APPLICATION NO.	FILING DATE	FIRST NAMED INVENTOR	ATTORNEY DOCKET NO.	CONFIRMATION NO.
10/045,467	11/08/2001	Fang-Hvi Chan	B-4373 619285-5	4294
36716 LADAS & PA	7590 02/09/2007 RRV		EXAMINER	
5670 WILSHII	5670 WILSHIRE BOULEVARD, SUITE 2100		LAO, LUN YI	
LOS ANGELE	S, CA 90036-5679	·	ART UNIT	PAPER NUMBER
			2629	-
			MAIL DATE	DELIVERY MODE
			02/09/2007	PAPER

Advisory Action Before the Filing of an Appeal Brief

Fig. 6(h)

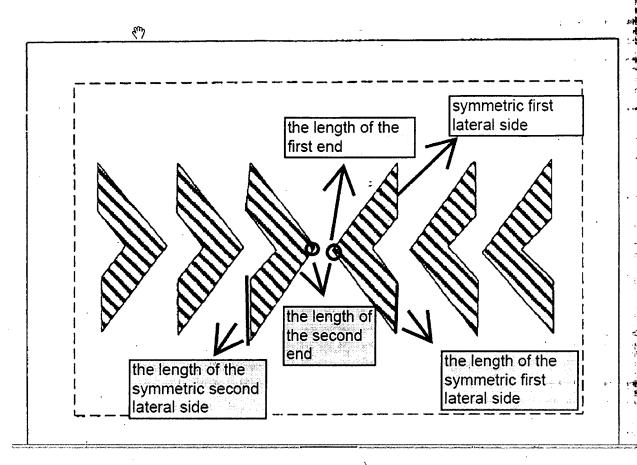
Continuation of 11. does NOT place the application in condition for allowance because: Kim et al teach four electrodes diposed on the first substrate and at corners of each display cell(see figures 4-6) and Liu teaches the length of the first end is less than the length of the two symmetric first lateral sides(see figure 6(h)(see final rejection and attachment).
